SAN FRANCISCO PLANNING DEPARTMENT

Discretionary Review Full Analysis

Date: October 2, 2014
Case No.: 2014.0718DD
Project Address: 333 PENNSYLVANIA AVENUE
Permit Application: 2013.0612.9341
Zoning: RH-2 (Residential House, Two-Family)
40-X Height and Bulk District
Block/Lot: 4040/025
Project Sponsor: Jeff Burriss
Studio12 Architecture
665 Third Street, #335
San Francisco, CA 94107
Staff Contact: Jeffrey Speirs – (415) 575-9106
jeffrey.speirs@sfgov.org
Recommendation: **Do not take DR and approve the revised project as proposed.**

1 Site Plan
1" = 10'-0"

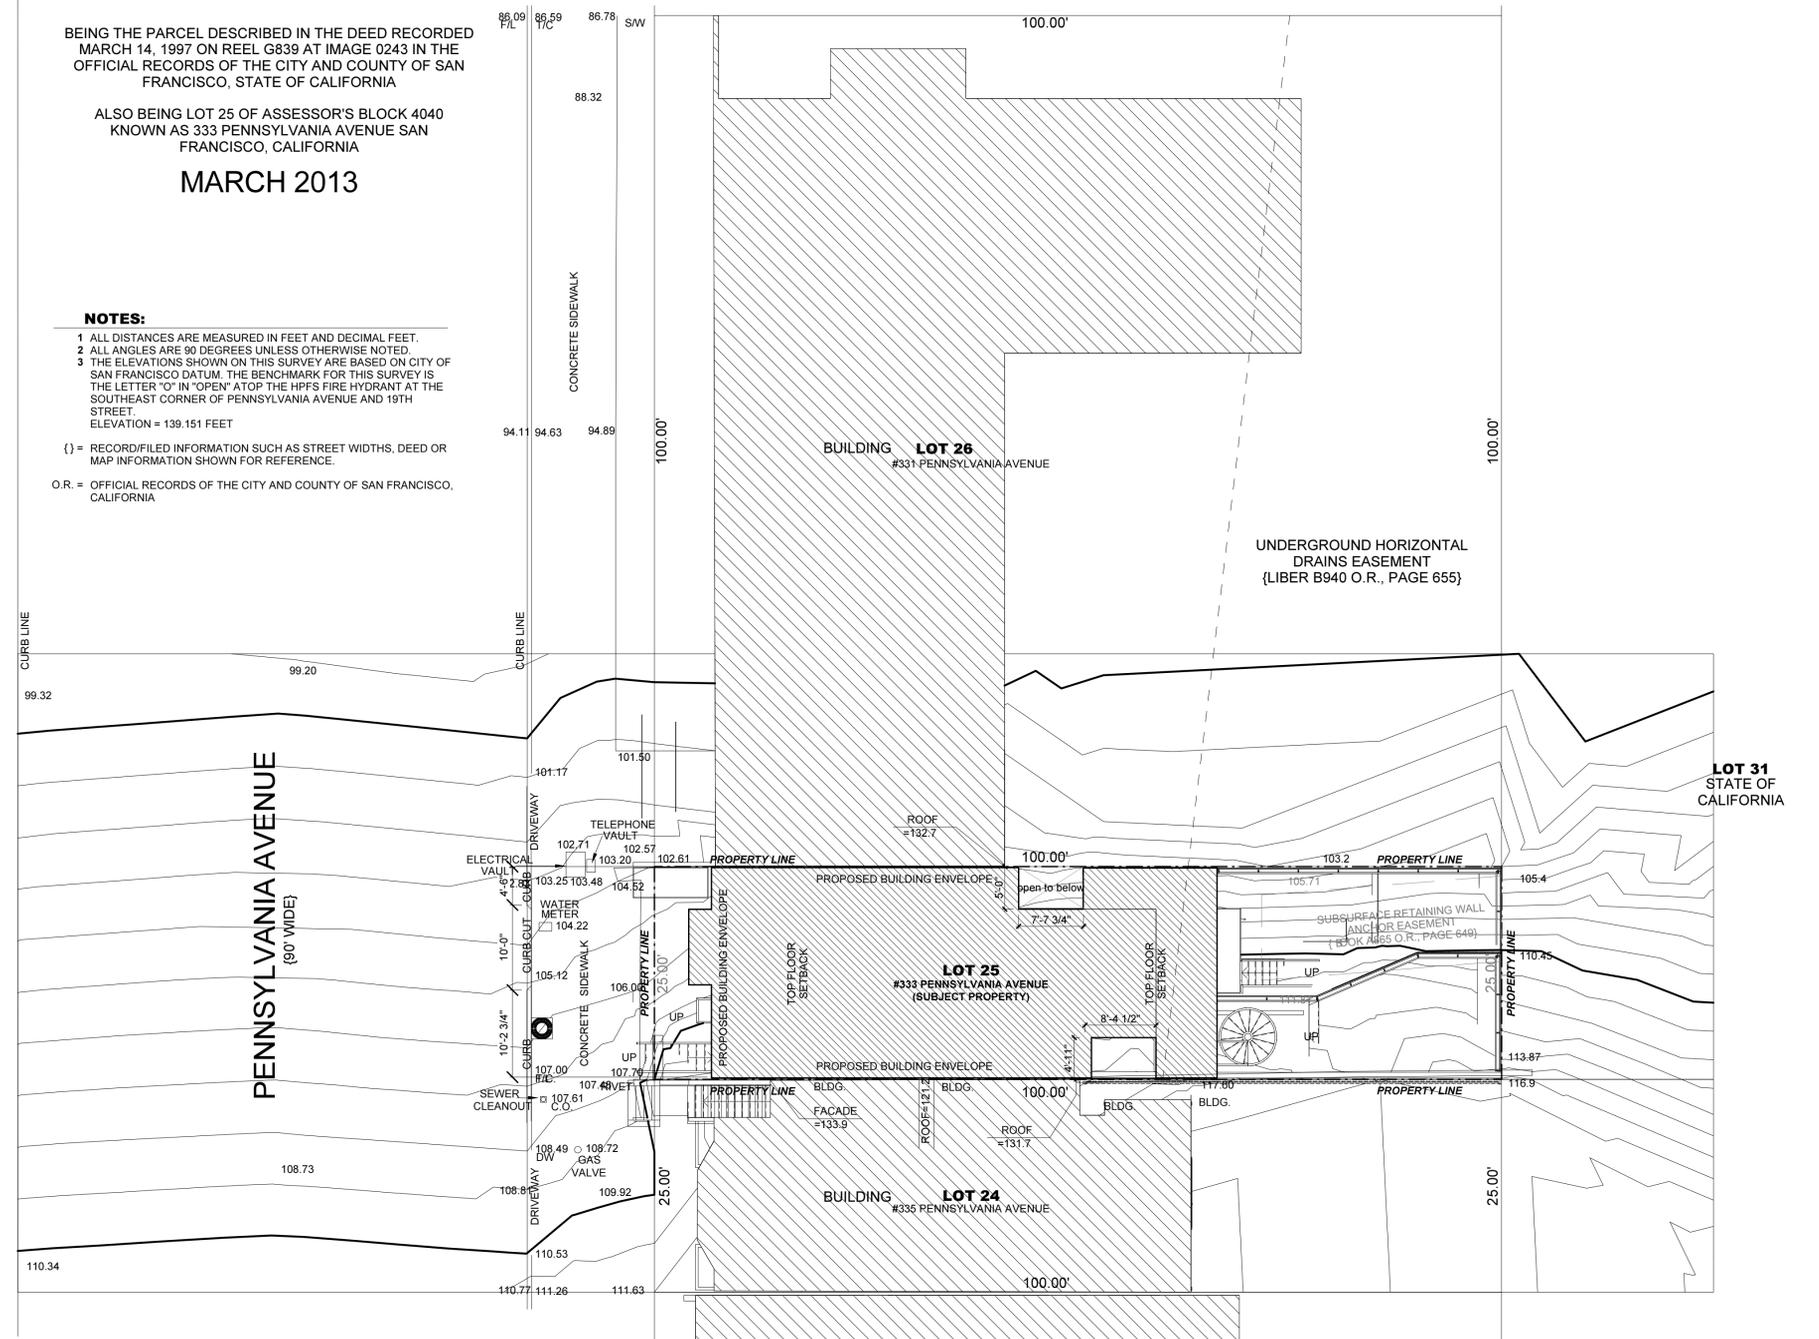
Curb Cut; No curb cut is shown on the plans per the RDG SEC. V p37. Based on this omission the 311 notice standard, review and compliance with the Planning Code was not met; therefore the notice was defective. **Please provide a curb cut per Planning Code Sec. 155 (c) and RDG Sec. V p37.**

- a. Show the width of both the existing and proposed curb cuts in the site plan (Plan Sheet A1.1). The recommended width of the proposed driveway is 12 feet.

- b. Clarify in the site plan (Plan Sheet A1.1) whether the existing curb cut would be removed as part of this project.
 - c. Consider adding more bicycle parking spaces because there would be larger/family-sized units.
 - d. Coordinate with SFMTA regarding relocation of on-street parking spaces.
4. **Noise.** *Eastern Neighborhoods FEIR Noise Mitigation Measure F-1: Construction Noise*, addressing requirements related to the use of pile-driving, would not apply to the proposed project because pile-driving would not be utilized as part of the project.⁷

Garage Entrance and Curb Cut. The proposed garage entrances do not comply with the Code. The garage entrances should be reduced to a single 10' wide garage entrance. The driveway will also need to be reduced accordingly and more landscaping will need to be added within the front setback. The proposed curb cut must also be indicated on the site plan and shall be no more than 10' in width. (Residential Design Guidelines pages 35 - 37)

2 Landscape Plan - Front Yard Planted Area
1/4" = 1'-0"

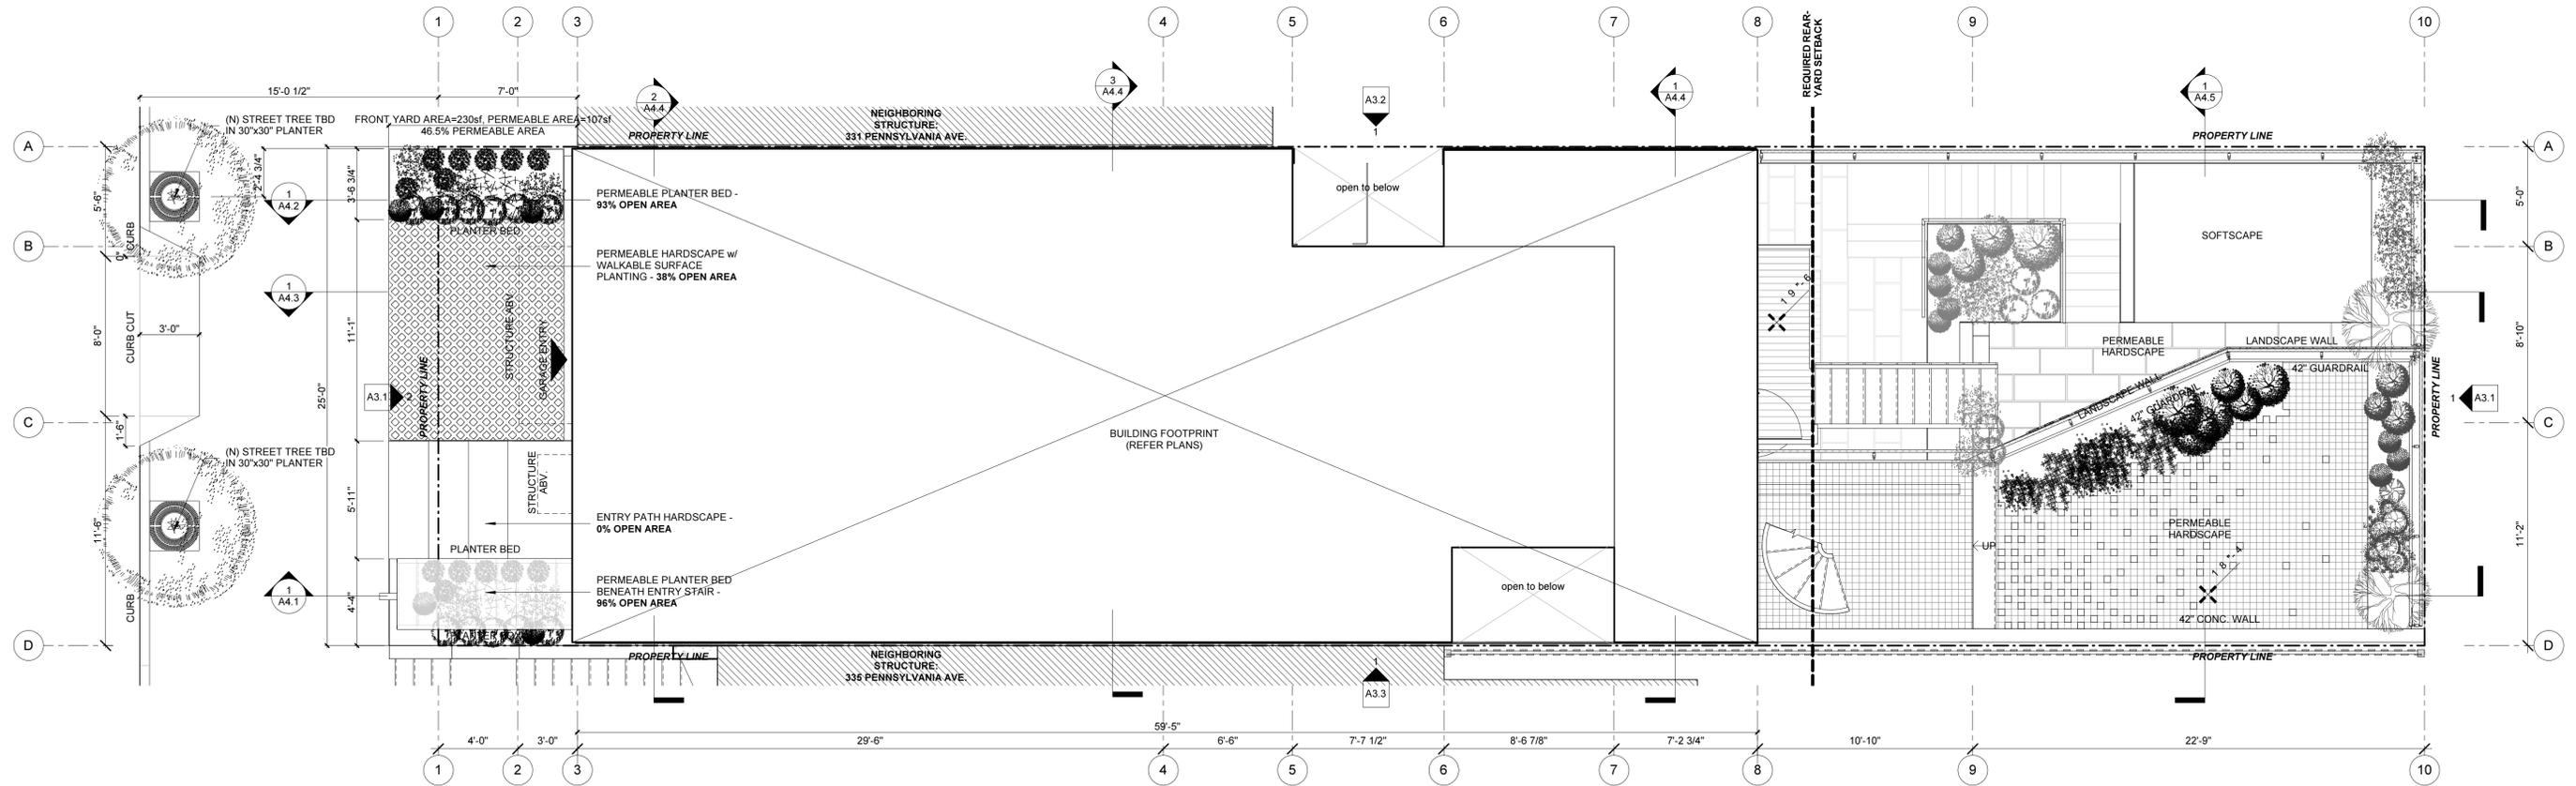
The Project's "landscaping" consists of a row of bushes separating the setback entry way, from the adjacent garage entrances (2). See Plan A2.1. "Landscaping must be an integral part of the project's design and not an afterthought." Planning Code Section 133(g) requires front setback areas be unpaved and devoted to plant material. (Emphasis added) The setback is all cement (99%).

Front setback planting; Landscaping is substantially and patently out of compliance with Sec 132(g) and RDG Sec III p14-15. Based on this omission the 311 notice standard, review and compliance with the Planning Code was not met; therefore the notice was defective. **Please provide 20% landscaping.**

8. Front setback planting; Landscaping is substantially and patently out of compliance with Sec 132(g) and RDG Sec III p14-15. The Planning Code plainly states, "and in every case not less than 20 percent of the required setback area shall be and remain unpaved and devoted to plant material..." Based on this omission, the 311 notice standard and compliance with the Planning Code was not met, therefore the 311 notice was defective.

Garage and Landscaping. The Department found the Project's previous design of two (2) one-car garage did little to enhance the streetscape at the ground level. A single 10 foot wide garage door, with similar curb cut, was requested. Free space within the front setback, to allow for more permanent landscaping, was requested to reduce the dominance of the garage, improve the pedestrian streetscape, and reduce the impact to on-street parking. The Project has been revised to provide a 10 foot curb cut, a single 10 foot wide code-complying garage door, and code-complying landscaping.
